Access Compliance Report

Public Rights-of-Way

Intersection ID: 49384	Main Street: SOUTH_DEVON_ST	Cross Street: SHORTHORN_ST	Location: S
ADA ID: 6EE14E892619	Ramp Type: PerpDiag	Initial Pass/Fail: Fail	Overall Compliance: No
			Severity Score: 21.25

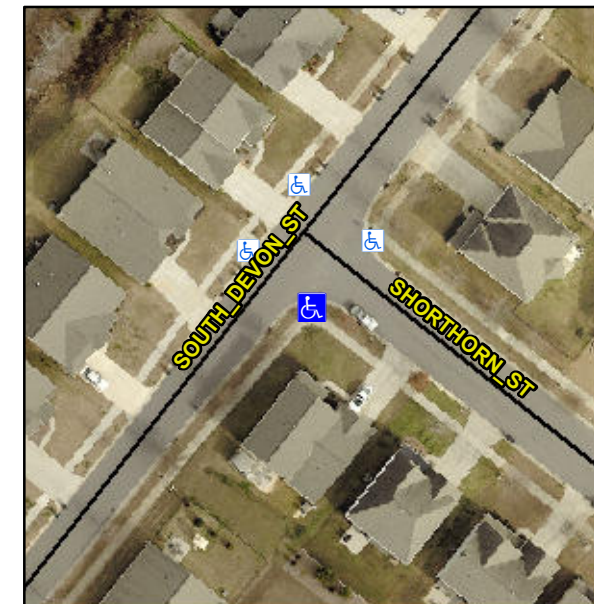
Not Found, R304.5.1, R304.2.2

Compliance	Description	Data	Compliance	Description	Data
N/A	Ramp Length (in)	82.0	No	Ramp Slope (%)	8.9
No	Ramp Width (in)	47.5	Yes	Ramp XSlope (%)	0.1
N/A	Flare Type LT	N/A	N/A	Flare Type RT	N/A
N/A	Flare Slope LT (%)	N/A	N/A	Flare Slope RT (%)	N/A
N/A	Flare Traversable LT?	N/A	N/A	Flare Traversable RT?	N/A
N/A	Landing Length (in)	N/A	N/A	DWS Provided?	N/A
N/A	Landing Width (in)	N/A	N/A	DWS Contrast?	N/A
N/A	Landing Slope (%)	N/A	N/A	DWS Length (in)	N/A
N/A	Landing X Slope (%)	N/A	N/A	DWS Full Width?	N/A
N/A	Landing Curb? (Y/N)	N/A	N/A	DWS Offset (in)	N/A
N/A	Shared Landing?	N/A			
N/A	Gutter Ponding?	N/A	N/A	Gutter Slope (%)	N/A
N/A	Gutter Lip Ht (in)	N/A	N/A	Gutter X Slope (%)	N/A
N/A	Painted X Walk1?	No	N/A	Painted X Walk2?	No
	X Walk 1 Direction	To NE		X Walk 2 Direction	To NW
N/A	X Walk 1 Width (in)	N/A	N/A	X Walk 2 Width (in)	N/A
	X Walk 1 Slope (%)	0.9		X Walk 2 Slope (%)	2.4
	X Walk 1 X Slope (%)	2.4		X Walk 2 X Slope (%)	1.7

Remove & Replace Curb Ramp With Two New Directional Ramps or Equivalent.
